APPLICATION NO.	FILING DATE	FIRST NAMED INVENTOR	ATTORNEY DOCKET NO.	CONFIRMATION NO.
10/560,560	06/23/2006	Ronald Christian Weber	003D.0084.U1(US)	6667
29683	7590	03/31/2008		
HARRINGTON & SMITH, PC 4 RESEARCH DRIVE SHELTON, CT 06484-6212			EXAMINER NGUYEN, PHUONGCHIT	
			ART UNIT 2839	PAPER NUMBER
			MAIL DATE 03/31/2008	DELIVERY MODE PAPER

# Office Action Summary

DETAILED ACTION

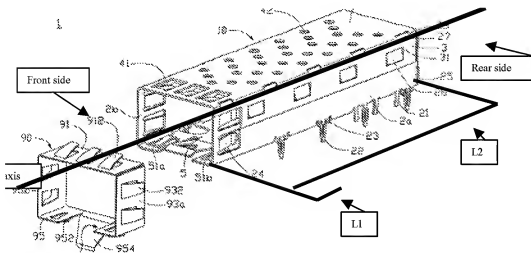
In regards to claim 1 and 5-6, Hwang discloses a shielding cage (10+90) extending along a longitudinal axis between a front side and a rear side (see marked-up below) and comprising a metal section (section of element 90) extending from the front side over a first length (L1) along the longitudinal axis characterized by a sheet metal section (section of element 10) extending from the rear side towards the front side over a second length (L2) along the longitudinal axis, the first length (L1) being substantially shorter than the second length (L2). Hwang discloses the invention generally all as claimed, but does not show the diecast metal section with mounting tails. However, Goodman et al teaches a diecast metal section (32) (col. 2, line 55) is over the sheet metal section (24) (col. 2, line 68) and (col. 3, lines 13-15) (fig. 1) and Hwang, himself, has the mounting tails (22, 23, 232, 222, 21, 212) for mounting the sheet metal section (section of element 10) to a circuit board (300); the mounting tails (22, 23, 232, 222, 21, 212) are solid integrated mounting tails of the metal section (section of element 10), and the mounting tails (22, 23, 232, 222, 21, 212) are pin tails (fig. 5). It would have been obvious to one having ordinary skill at the time the invention was made to modify the metal section of Hwang et al by having the diecast metal section as taught by Goodman et al for having a thicker metal section to increasing the holding force with the shell metal section at one end and the mating connector at another end and adding the additional mounting tails from the teaching of the mounting tails of the sheet metal section to the metal section of Hwang for increasing the good connecting between the metal section to the circuit board by itself.

In regards to claim 2, Hwang discloses the shielding cage (10+90) wherein the ratio of the first length (L1) to the second length (L2) is in the range 1:3 to 1:6.

In regards to claim 3, Hwang discloses the invention generally all as claim, but does not show the ratio of the first length (L1) to the second length (L2) to be in the range 1:4 to 1:5. It would have been
